**Validation report form for post-registration changes for
CDM project activities
(Version 03.0)**

Title and UNFCCC reference number of the project activity	Landfill Gas Recovery and Flaring Project in El Verde Landfill Leon UNFCCC ID: 3378
Process track	<input type="checkbox"/> Prior approval <input checked="" type="checkbox"/> Issuance <input type="checkbox"/> Renewal of crediting period
Version number of the validation report	Version 1.1
Completion date of the validation report	22/10/2019
Type(s) of PRCs	<input checked="" type="checkbox"/> Temporary deviations from the registered monitoring plan, applied methodologies, standardized baselines or other methodological regulatory documents ¹ <input type="checkbox"/> Corrections <input type="checkbox"/> Changes to the start date of the crediting period <input type="checkbox"/> Inclusion of a monitoring plan <input type="checkbox"/> Permanent changes to the registered monitoring plan, or permanent deviation of monitoring from the applied methodologies, standardized baselines or other methodological regulatory documents <input type="checkbox"/> Changes to the project design <input type="checkbox"/> Changes specific to afforestation an

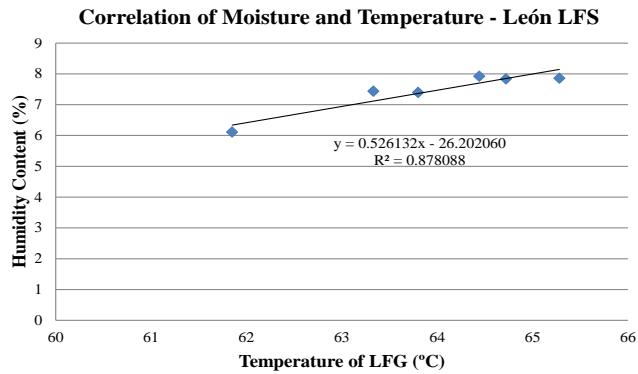
- 1) As per registered PDD, monitoring parameter "volumetric fraction of H₂O in time interval t on a dry basis (vH₂O,t,db)" is estimated using equation (8) of the "Tool to determine the mass flow of a greenhouse gas in a gaseous stream" version 3.0, for wet gaseous stream. Nonetheless the parameter has been determined in a different manner. Correction is requested.

- 2) Registered PDD states that as per the of the "Tool to determine the mass flow of a greenhouse gas in a gaseous stream", version 3.0, under normal operation conditions, the volumetric flow of landfill gas which is sent to flare is monitored as VLFG,sent_flare,y,db (m³ dry gas/h) since the temperature of the landfill gas (Tt) is less than 60°C at the flow measurement point most of the time (Option A). The same volumetric flow is named as VLFG,sent_flare,y,wb (m³ wet gas/h) in case of wet basis of the gas, demonstrating that the temperature of the gaseous stream (Tt) is more than 60°C at the flow measurement point following by converting the measured volumetric flow from wet basis to dry basis (Option B). Further, the submitted Monitoring Report, Verification report and Spreadsheets provide the values of the volumetric flow in normalized cubic meters (Nm³). However, as per the applied methodological tool "Tool to determine the mass flow of a greenhouse gas in a gaseous stream", version 3.0, particularly Options A and B applied by the project activity, the volumetric flow of landfill gas shall be monitored in operation conditions. Clarification is requested.

- 3) Methane density (DCH₄), page 13 of the MR – by scanning through ACM0001 Version 18, we view that the way DCH₄ is determined is not in accordance with ACM0001 Version 18. On further looking we observed that the applied approach is defined until ACM0001 Version 11 and after that subsequent version of meth has different provision. So, parameter DCH₄ is not in accordance with applied methodology. Clarification is requested.

- 1) During the first crediting period, the CDM-PDD did not have any reference to the "Tool to determine the mass flow of a greenhouse gas in a gaseous stream" to correct the flow to dry basis when the temperature was greater than 60°C and there was not guidance to properly apply it. Moreover, considering that during the monitoring period no separate monitoring of temperature and pressure is necessary since the PP is using flowmeters that automatically express LFG volumes in normalized cubic meters, there is no measurement of the pressure of the gas to apply the Option 2 (Simplified calculation without measurement of the moisture content) of the "Tool to determine the mass flow of a GHG in a gaseous stream" version 3.0. Considering such situation, for the first submission of this monitoring period, rather than using the using equation (8) of the "Tool to determine the mass flow of a greenhouse gas in a gaseous stream" version 3.0, the PP hired the third party consultancy IECASA to measure the moisture content of the gas (vH₂O,t,db) as can be evidenced with the "Moisture Content Report_Leon_Feb-11". The experiment was conducted by artificially (i.e increasing the booster's suction) increasing the temperature of the gas above 60°C and measuring the moisture content of the gas to find a correlation between the temperature of the gas and its moisture content, as follows:

Using the above values, the correlation was plotted as follows:

In the first submission of the current monitoring period, the PP corrected the monitored values of the parameter "VLFG,sent_flare,y,db" to dry basis for the cases when T exceeded the 60°C using the following correlation based on the data measured by IECASA in the "Moisture Content Report_Leon_Feb-11":

- 1) In line with the clarification provided by the PP, during the first crediting period, the CDM-PDD did not have any reference to the "Tool to determine the mass flow of a greenhouse gas in a gaseous stream" to correct the flow to dry basis when the temperature >60°C, and the PP provided an alternative method in line with thermodynamics principles and such situation was not updated in renewal of the crediting period. The PP decision to conservatively disregard all flows values T > 60°C (wet basis) is correct and in line with the registered PDD choices and also the re-calculated ER value is conservative; this is verified in columns D and E of spreadsheet /error/ in xls file Raw_Data_EI_Verde_6MP_v5.
